AGENDA

President and Board of Trustees
Village of Arlington Heights
Board Room

To: Charles Witherington-Perkins, Director of Planning and Community Development
From: Sam Hubbard, Development Planner
Date: 5/2/2019
Re: Village Board Meeting on May 6, 2019 - PC #19-002: Yamada America

File Number: PC 19-002
Project Title: Yamada America
Address: 955 E. Algonquin Road
PIN: 08-15-303-013

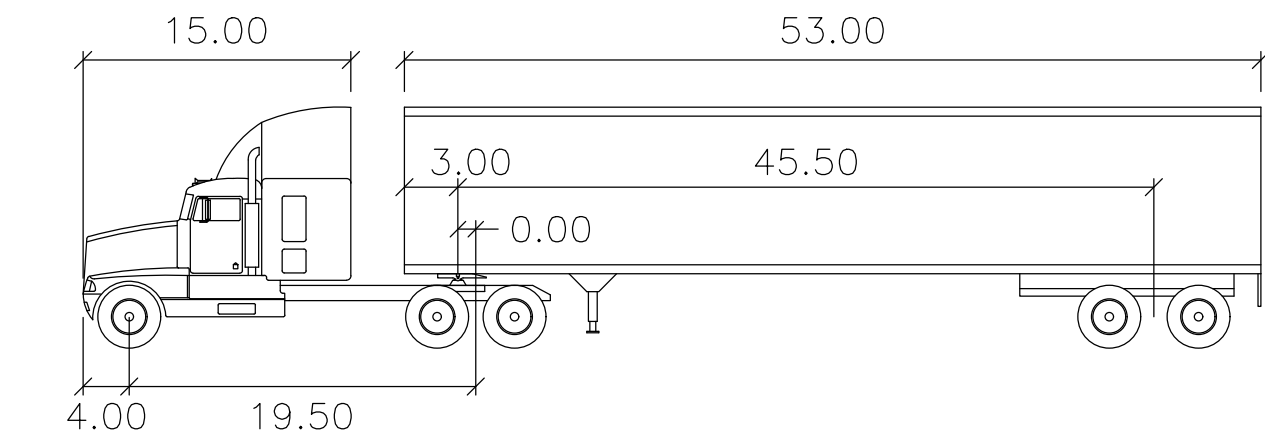
Staff has also asked the petitioner to prepare an exhibit showing what improvements would be necessary to widen out the single-lane rear/side driveway that extends around the side and rear of the building with access to Algonquin Road. If this drive was widened to allow truck access, trucks could stage in this area until a truck dock is available. Additionally, if this rear/side drive aisle was accessible to trucks, it would reduce the impact of staging on Cedar Glen.

The exhibit showing the necessary improvements is attached. The petitioner has pointed out that implementing these improvements would decrease the amount of greenspace on the site and would trigger stormwater upgrades and an MWRD permit. Additionally, they may require an IDOT permit to widen the Algonquin Road entrance to allow for truck travel, as well as further modifications to the Cedar Glen curb cut. The Staff Development Committee does not believe that the construction of these improvements is warranted at this time given the low volume of truck traffic from the site, but would like to reserve the right to require their implementation in the future if conditions warrant their construction.

1 SITE PLAN
A1.0 1" = 20'-0"

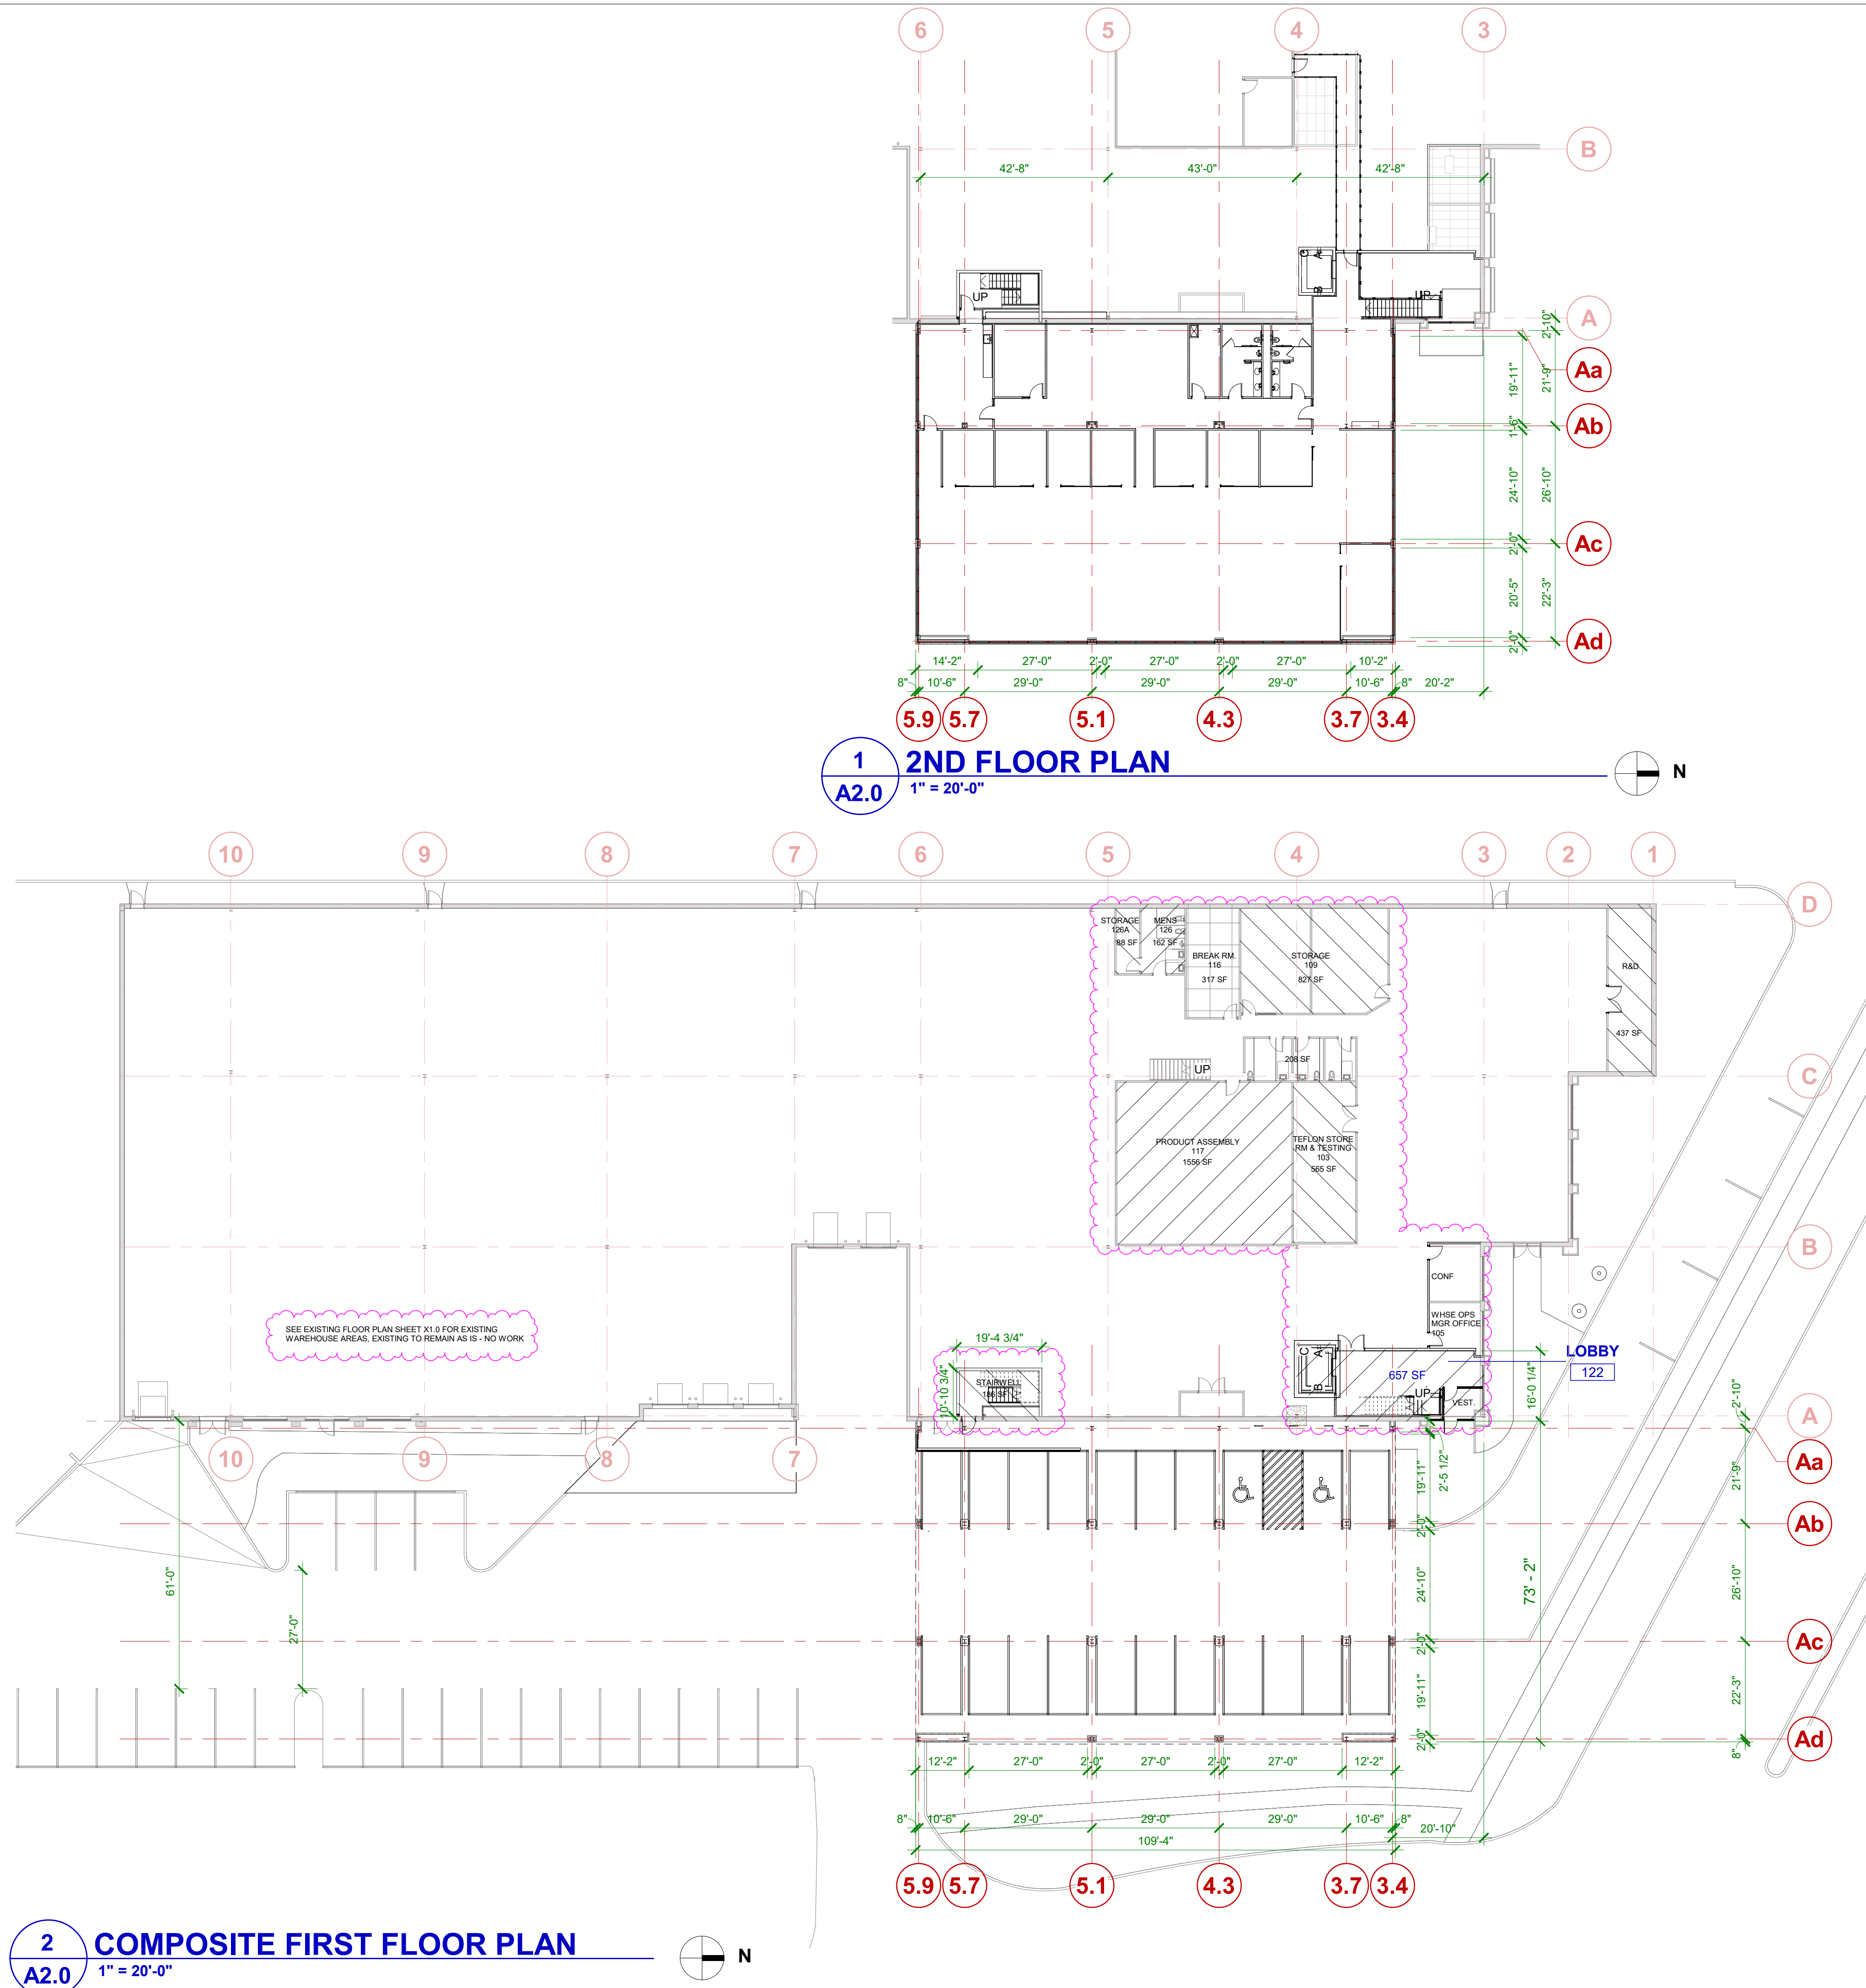
13. Sheet A1.0 includes a label "12" (Bike Racks), however, there are no bike racks shown on the site plan. Please show the location of the proposed bike racks and clarify how many bicycle parking spaces will be included within the racks. A total of 4 bike parking spaces are required.

16. Does the total size of the office portion of the building still match the size as previously contemplated, per my 12/18/18 email? It appears that there are discrepancies between what is listed on sheet A1.0 in the building data square footages and the parking calculations. Additionally, the description in the parking calculations do not appear to include the 2nd floor stairway. Please include a breakdown of all office spaces included in the calculation, as well as a floor plan showing these spaces per comment #10.

17. Three handicap accessible stalls are required for parking lots that include 51-76 parking stalls.
18. The project narrative indicates that there are 15 warehouse employees, however, the parking calculations on page A1.0 indicate that there are 17 warehouse employees. Please clarify and revise the plans/project narrative accordingly.

11. Parking stall LxW dimension, and drive aisle width have been added to sheet A1.0 for the parallel parking stalls at the north end of the property. The parking spaces along the front has been revised to 3 from 4 to maintain a max total of 50, which exceeds the 46 minimum spaces required.

12. There are two possible transformer locations indicated on sheet A1.0. The east side of the building location is noted as the preferred location (see keynote 6 on that plan) subject to ComEd approval. If this does not work for ComEd, the alternate location would be on the north side (see keynote 7 on that plan). The Landscape Plan L1.0 has been revised to reflect the same layout as A1.0. An existing tree at this location would be affected by this alternate location so a clouded alternate replacement trees have been also indicated). Additionally, the planter at the northwest corner of the building addition on Landscape Plan L1.0 has been revised to reflect the same layout and size as shown on A1.0 and the civil engineering plans.

13. The Site Improvement Legend on Sheet A1.0 uses numbers in boxes as keynote targets. There are 4 individual bike rack shown along the building The bike rack keynote target has been corrected to read "12", and not 1. Additionally the Legend keynote has been revised to indicate "4 bike racks to accommodate a minimum of 4 bikes".

14. The Site Improvement Legend on Sheet A1.0 has been revised to include a description of the "Alternate transformer alternate: brick screen wall to match transformer height, TBD". We are waiting for ComEd's specs on the transformer size.

15. The unlabeled feature was removed from A1.0. It was the proposed location of the transformer in an earlier iteration.
16. The areas on my 12/18/2018 email to S. Hubbard, areas are described as existing areas (i.e., 42,422 sf building footprint plus mezzanine areas, and 38,709 sf building footprint only). A1.0 is consistent with that. However, after review of area calculations a few minor errors were found. The Areas and Parking Calculations have been corrected accordingly on revised A1.0 with a corrected breakdown of the areas and the parking calculation.

17. Understood, although we do not expect the required parking total to exceed 50.
18. There are 17 office and 15 warehouse staff. The narrative is correct. The parking calculation was in error. Drawing A1.0 has been corrected.
